REPORT NO: DS 2023-003

SUBJECT: Modifications to Draft Plan of Subdivision 30T-19601, Badenview
Developments Inc., Wilmot Employment Lands, New Hamburg

Attachment A	Approved Draft Plan
Attachment B	Changes to Township Conditions of Draft Approval
Attachment C	Revised Draft Plan
Attachment D	West property line conceptual cross-sections

Revised Draft Plan

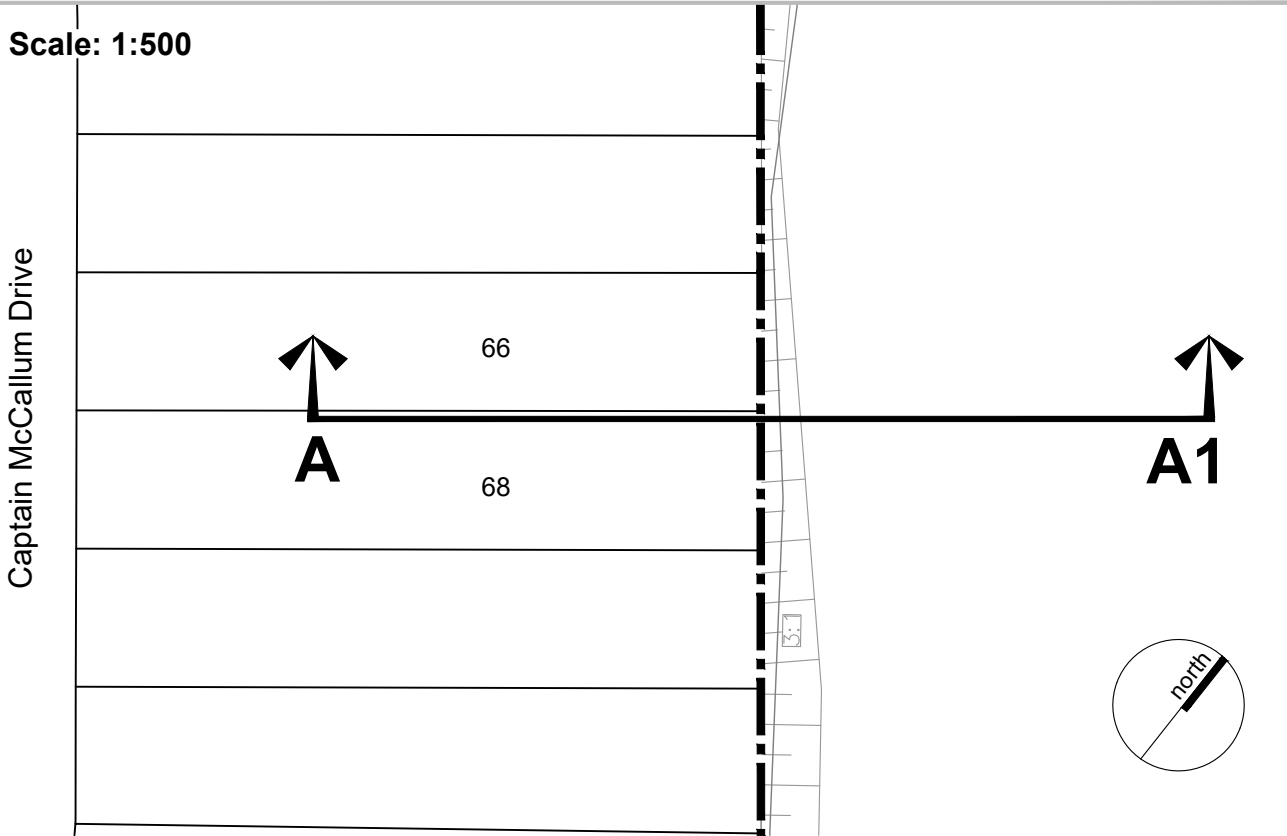
Changes include the consolidation of drainage channels, a minor re-location of Street 2 (now Vernon Erb Drive), removal of a previously proposed noise attenuation berm, and registration as one stage instead of two.

The design has been modified to consolidate the two drainage channels originally proposed and to shift Street 2 (now identified as Vernon Erb Dr.) slightly west, in order to maximize the size of the central development block (Block 3) within the plan. The applicant has indicated that the resulting reduced depths of Blocks 1 and 2 better reflect the potential lot size needs for light industrial/commercial uses anticipated to be located within that block.

| 11. | Aug. 30, 2022 | Further revs. to Drainage Channel width along northeast part of property; | DGS |
| 10. | May 18, 2022 | Revise Drainage Channel width along northeast part of property; | DGS |
| 9. | Apr. 7, 2022 | Revise Drainage Channel location; Shift Vernon Erb Drive; | DGS |

1. That this approval applies to plan of subdivision 30T-19601 by MHBC Planning, dated ~~January 25, 2021~~ **August 30, 2022** which shows a total of 6 industrial development blocks, 2 stormwater management blocks, ~~4~~**3** drainage channels, ~~5~~**4** reserve blocks (0.3m) and 3 streets proposed to be developed in ~~2 stages~~ **1 stage**.

2. That the following shall be conveyed to the Township of Wilmot for the purposes stated therein, at no cost and free and clear of all encumbrances:
 - a) ~~Stage 1, Blocks 5 and 6~~ **6 and 7** as a stormwater management facility;

- b) ~~Stage 1, Blocks 7, 8, 9 and 10~~ **9, 10 and 11** as overland drainage and servicing channels; and,
 - c) ~~Stage 1, Blocks 11, 12, 13, 14 and 15~~ **12, 13, 14, and 15** for 0.3m reserves

West property line conceptual cross-sections

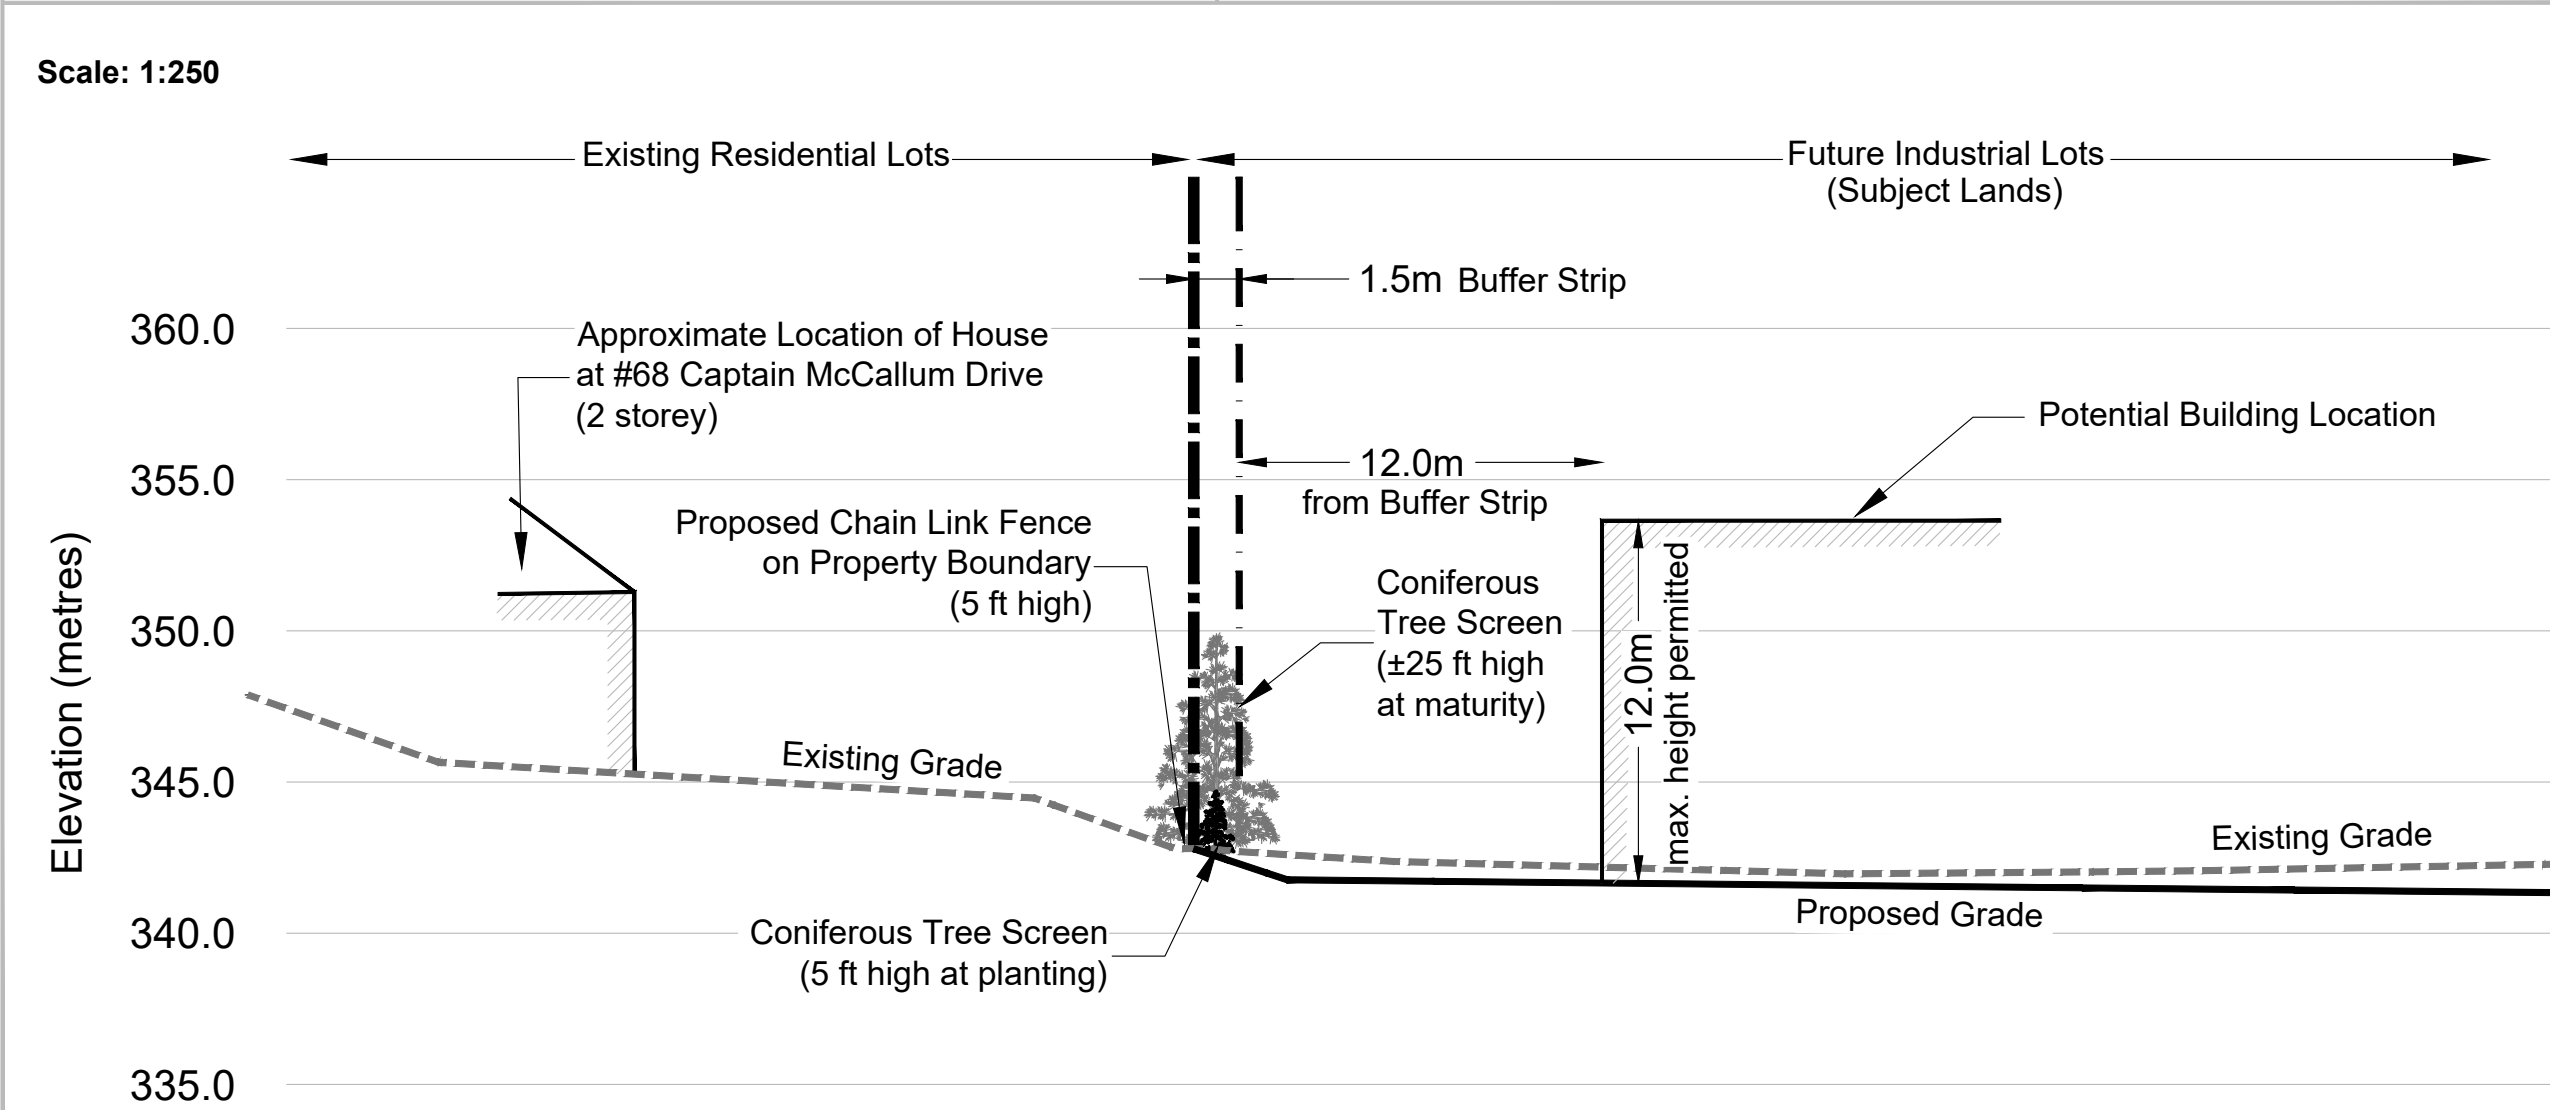
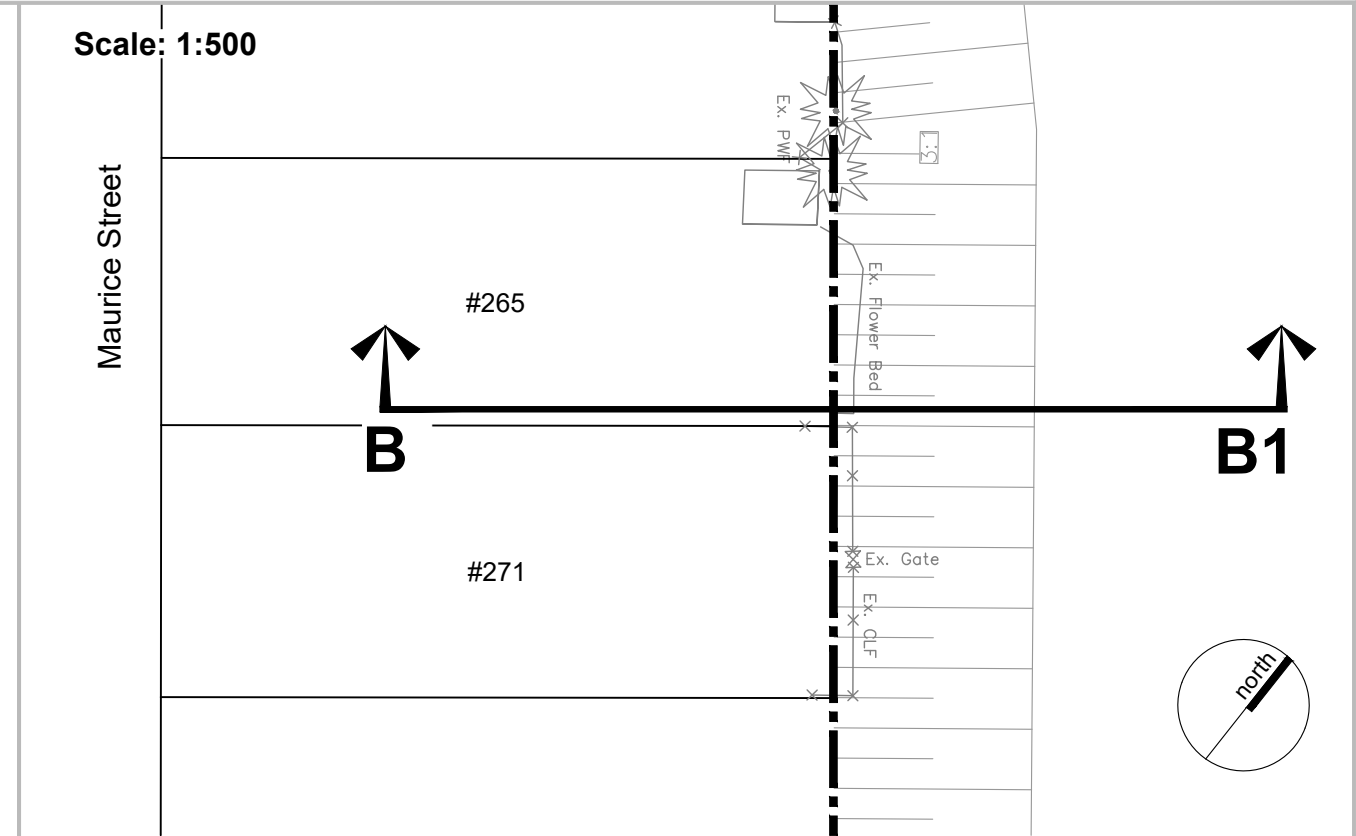
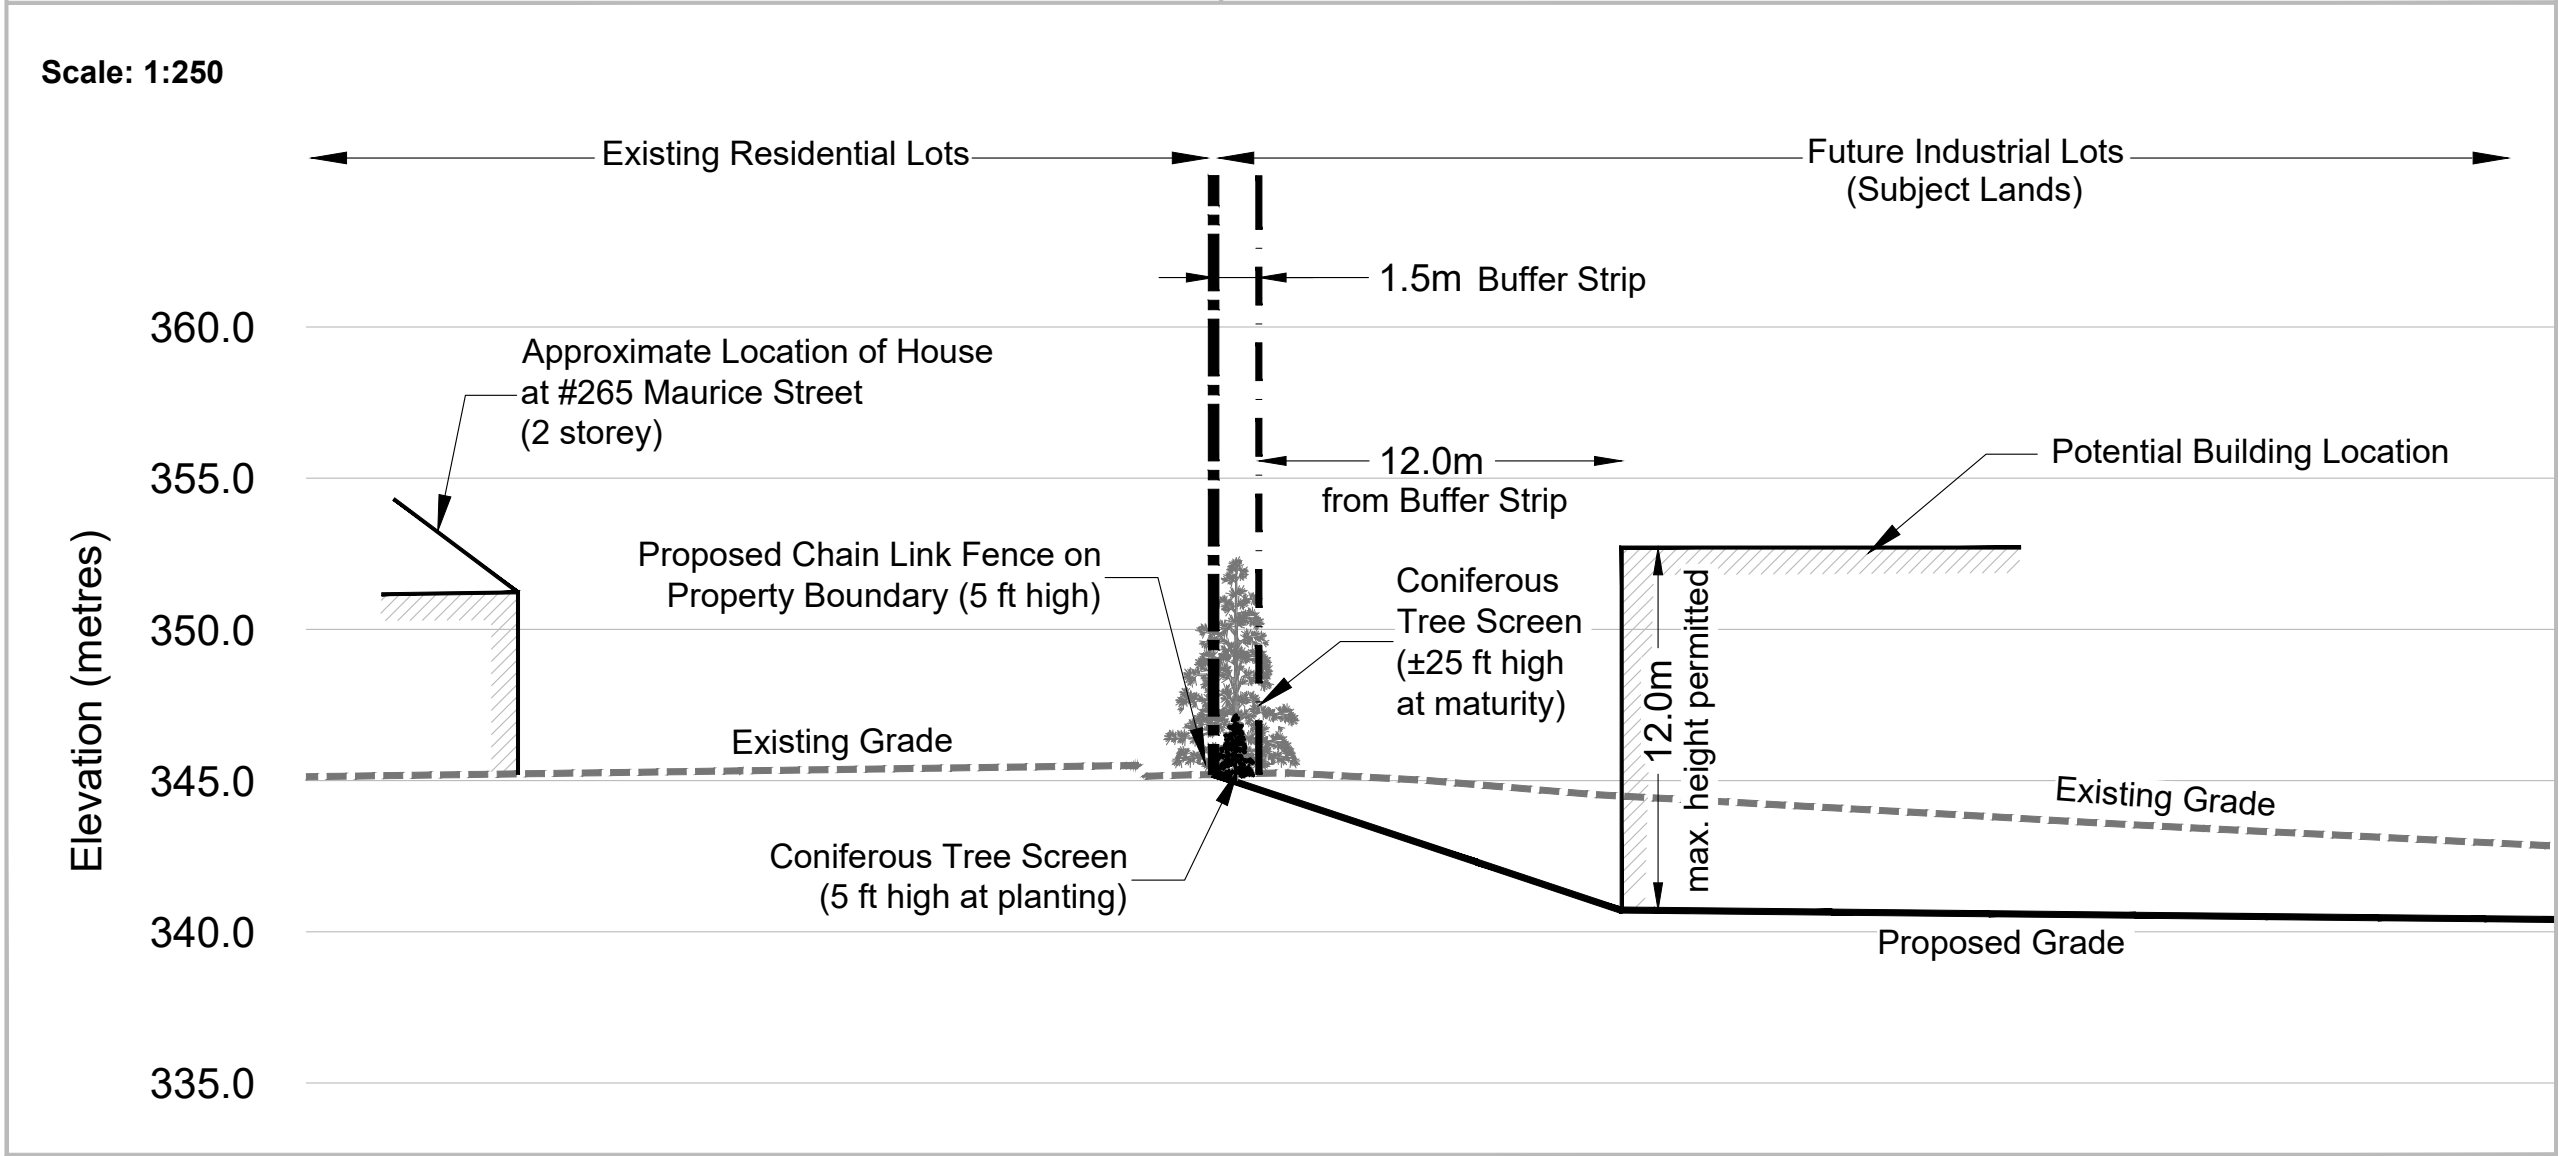
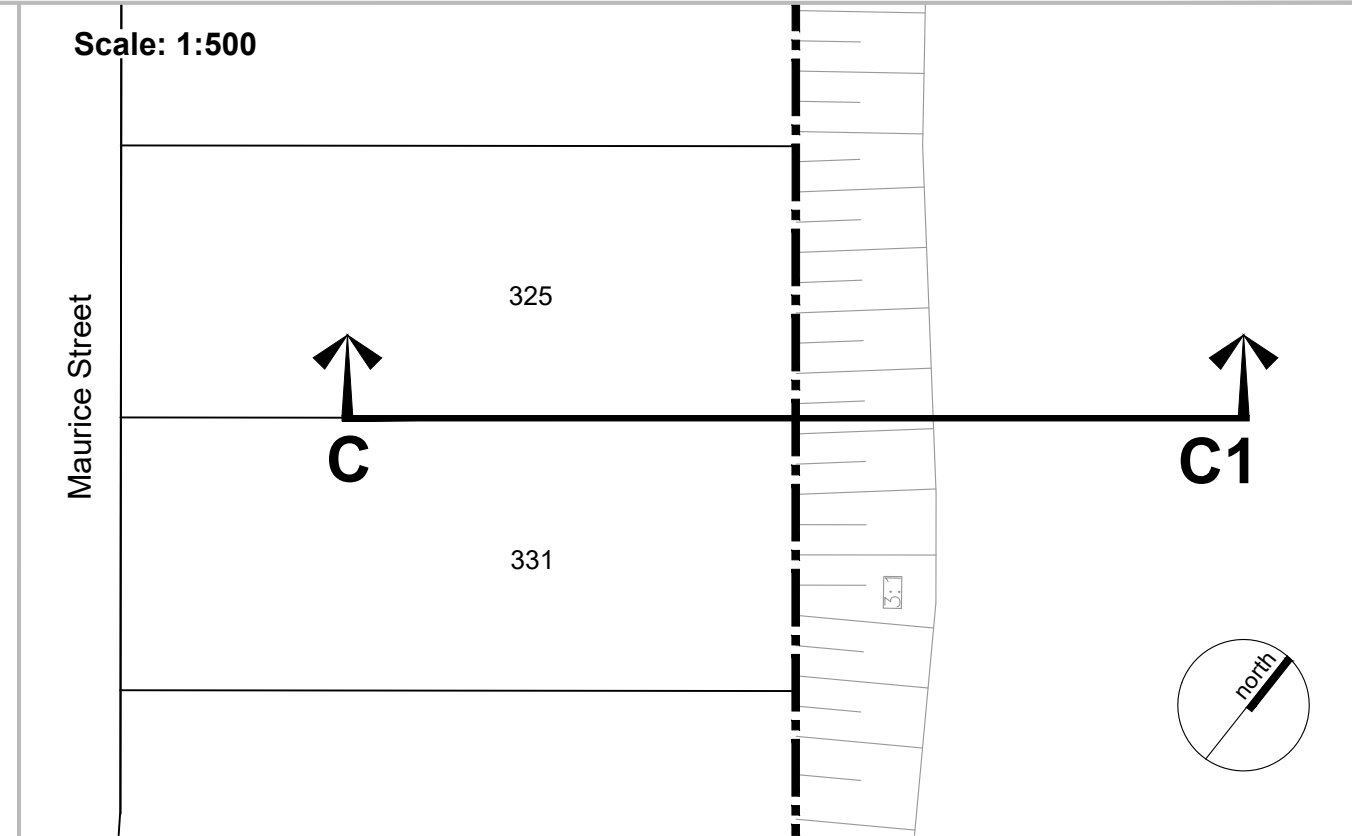
While not required for noise mitigation, the berm was anticipated to provide the added benefit of visual buffering. To ensure that visual mitigation measures remain in place along the west property line, the developer proposes to maintain a 13.5m buffer area between the west property line and any proposed building. This area will accommodate a 3:1 slope from the higher elevation of the residential lands to the lower finished elevation of the employment lands. Conceptual cross-sections at several points along the west property line illustrate the grade difference and proposed landscaping at or close to the rear property line. These illustrations are included as Attachment D.

Staff propose that the Township retain an easement over the proposed buffer area to ensure the slope and landscaping are preserved. The revised conditions of draft approval implement the requirements for the 13.5m landscaped buffer secured through a Township easement.

3. **That a 13.5m easement be conveyed to the Township of Wilmot along the west side of Block 1 for the purposes of preserving a landscaped 13.5m buffer along west property line that abuts residential development.**
